WOKINGHAM
BOROUGH COUNCIL

Pre-application Response Letter

Site Address: Land at Eversley Road, Arborfield, RG2 9PJ

Proposal: Pre-application advice for the proposed construction of a PFS comprising, forecourt and canopy with 8 fuel pumps, new store and car wash in addition to parking, air and water servicing, ATM, outdoor seating, bicycle parking, landscaping and access and associated works.

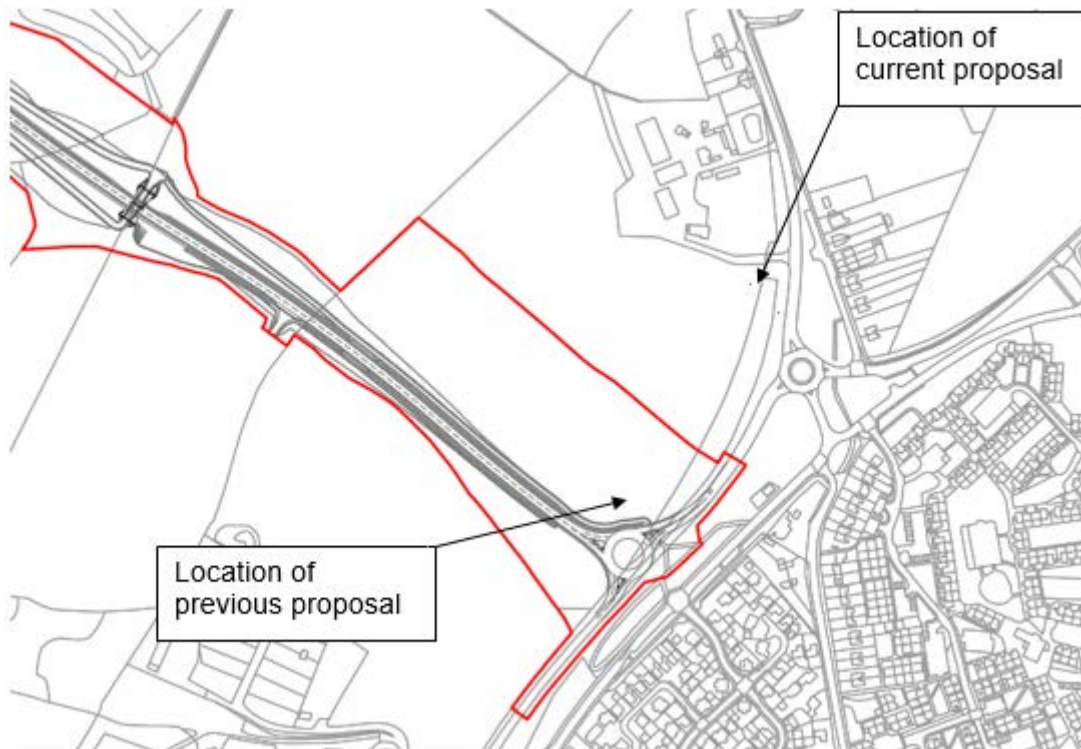
The previous pre-app relied on the approval of the Arborfield Cross Relief Road. The current proposal has been moved further to the north. The relief road was approved under application number 172209 on 23/01/2018 and was varied under application number 181802 on 03/09/2018. The below plan shows the proposed location of the road, including its junction with the A327 and the location of the current proposal and previous proposal:
